Instruction Sheet

for Switch/Bracket

FIGURE 1

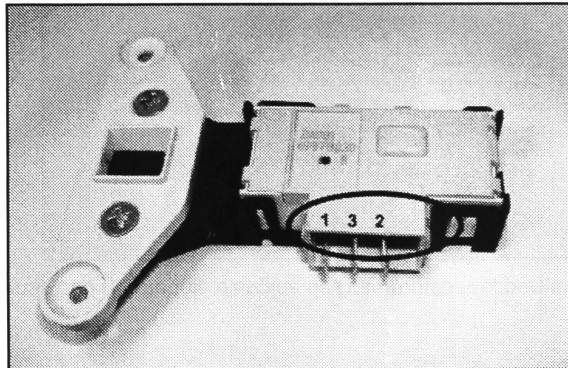
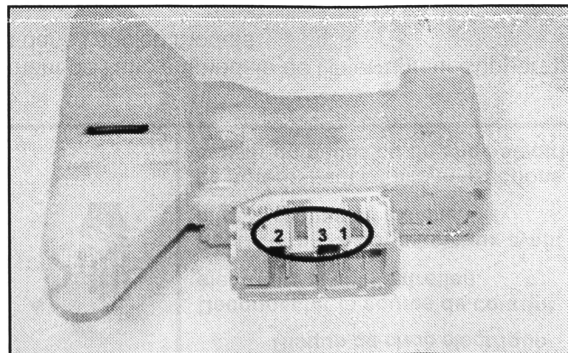
IMPORTANT: The original Brown Bracket and Switch have the terminals as 1-3-2. See *Figure 1*

IMPORTANT: The new Switch/Bracket assembly has the terminal as 2-3-1. See *Figure 2*

The connections should be as follows:

BP1 – Black Wire

BP2 – Red Wire

BP3 – Brown Wire

NOTE: It is important to attach the correct colored wire to the correct numbered terminal, as shown above. Failure to do so could result in damaging the electronic controls.
